Bulletin

MODEL BENTLEY MARK VI

MODIFICATION.**For Category 1 Action:**

- a) Rear Axle Retaining Bolts.
- b) Rear Brakes - Equal wear Linkage.

FIG. 1.

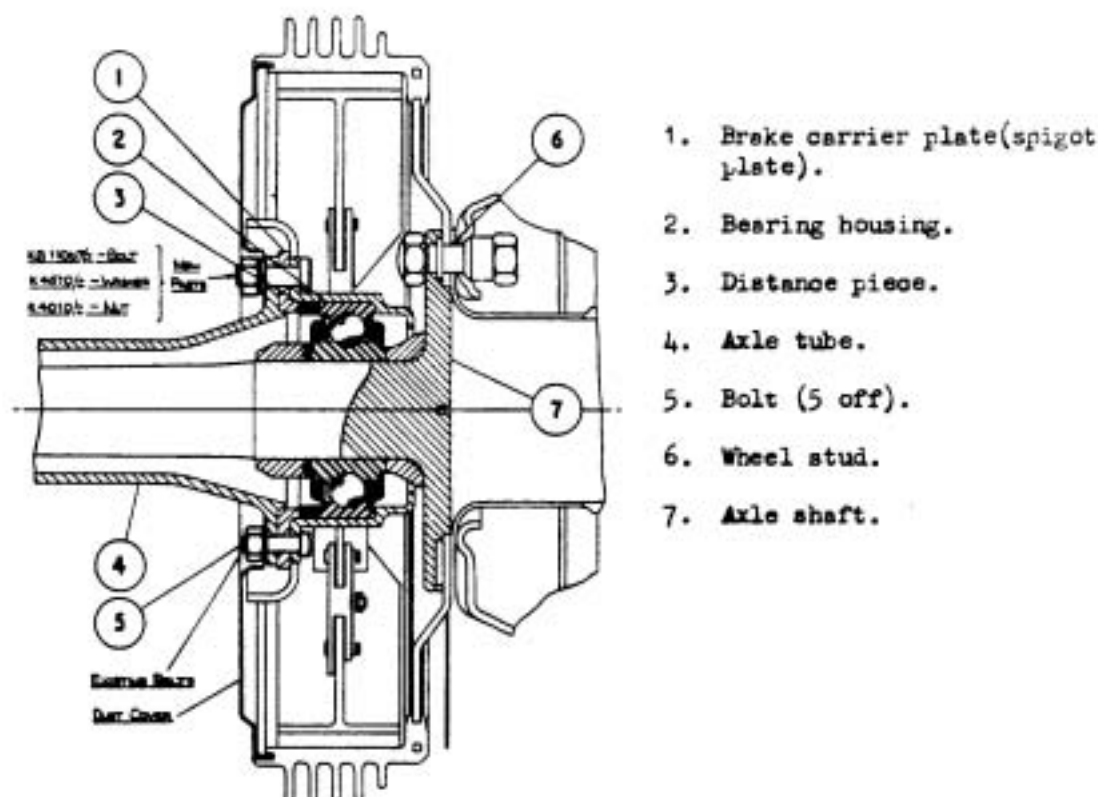
It has been decided to fit $3/8"$ diameter bolts as shown on Fig.1, in place of the existing $5/16"$ diameter bolts (5) which retain the rear axle shaft bearing housing (2) and the brake carrier plate (1) to the axle tube. It has also been decided that opportunity should be taken to reverse the equal wear brake linkage of the rear brakes and fit the stiffened linkage which consists of a new push rod and jaw.

- (iii) Unscrew the five 5/16" B.S.F. nuts from the bolts (5 Fig.1) lying inside the recess in the dust cover at the rear of the brake carrier plate and gently draw out all the bolts which retain the axle shaft bearing housing (2) and the brake carrier plate (1) to the axle tube (4).

FIG. 2.

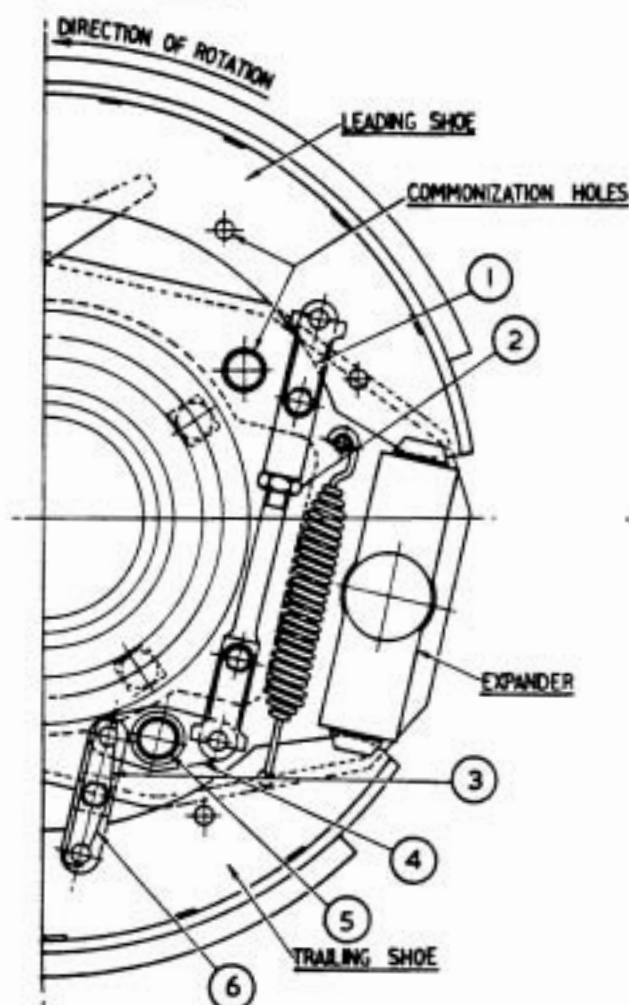
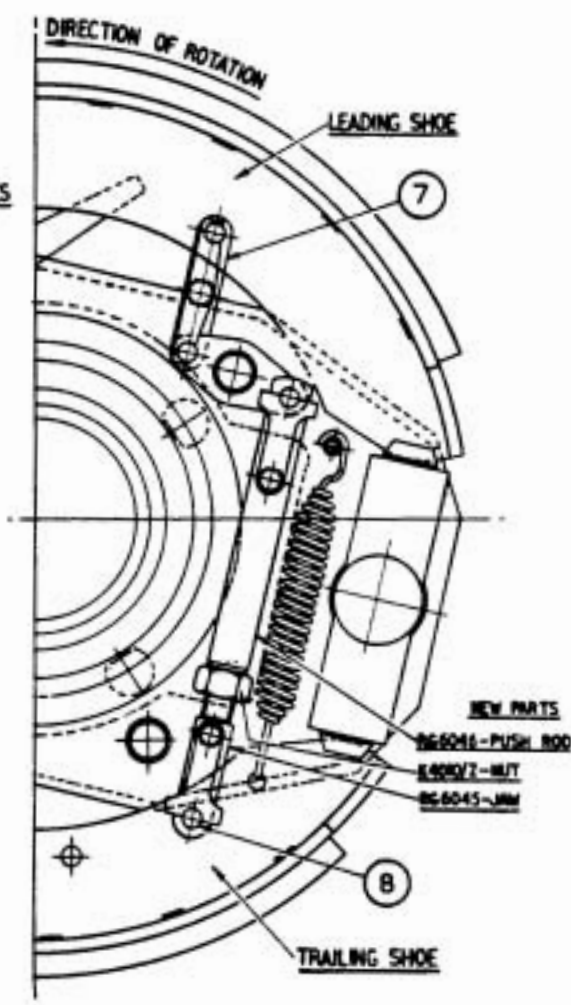
Although some cars will already have the unstiffened linkage reversed and others will have the stiffened linkage, it is desired that all cars should be brought to the full modified standard as soon as possible. The decision to reverse the brake linkage and fit the stiffened type is in order to eliminate the possibility of the rear brakes developing a jamming action (sagging), due to the trailing shoes pivoting about the inter shoes equal wear linkage instead of about the adjuster end of the shoe. A modification has been introduced, moving the point of attachment of the linkage to the trailing shoe nearer the adjuster. This is done by simply reversing the linkage and the central pivot of the linkage, so that the shorter of the two links is now attached to the leading shoe instead of to the trailing shoe as was previously the case. (See Fig.2).

- (ii) Unscrew the two setscrews retaining the locking plates (1 & 6 Fig.2) on the inter shoe linkage nearest each shoe and pull out the pins holding the links to the shoes and withdraw the complete linkage away from its pivot (5). Do not disturb the setting of the push rod by turning the jaw relative to the rod. It is advisable before removing the linkage, to check the locknut (2) on the push rod for tightness.
- (iii) With a 7/16" (B.S.F.) cranked ring spanner, remove the locknut, the Grover and plain washer from the back of the pivot (5) and transfer the pivot from its position just above the lower or trailing shoe to the existing hole in a similar position just below the upper or leading shoe. (See "Modified" Drawing Fig.2).

FIG. 1.

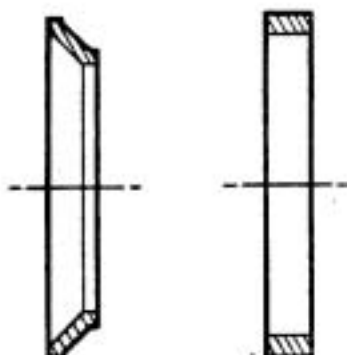
In addition to carrying out the modifications as detailed in Bentley Service Bulletin No: BB-73 (Section L), it has also been decided to reduce the nip on the outer race of the ball bearing on the axle shaft to zero by reducing the width of the distance (adjusting) piece, (3 Fig. 1 of Bulletin BB-73) from 0.002" to 0.003" (0.050 mm to 0.076 mm) whatever the width of the distance piece may be found to be.

- (i) After the removal of an axle shaft as described in Bulletin No: BB-73, remove the distance piece from the ball bearing housing which is a free fit.
- (ii) Carefully measure the width of the distance piece and reduce the width by machining 0.002" to 0.003". The distance piece is made of mild steel. In the unlikely event of machining facilities not being available, then it will have to be carefully reduced by hand, keeping the faces parallel.
- (iii) Repeat for the opposite side.

FIG. 1. SECTION - REAR AXLE SHAFT ASSEMBLY.

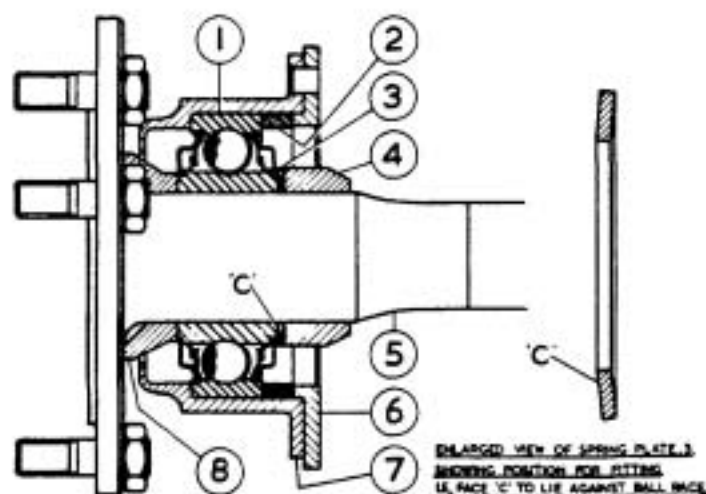
NOTE: It has now been decided that the bore of the ball bearing and the collar should be lubricated with a straight S.A.E.30 engine oil prior to pressing them on to the axle shaft.

After pressing on the collar, apply a final load of 15 tons (15240 Kilos) to ensure that the distance piece, bearing, spring plate and the collar are in firm contact with one another.
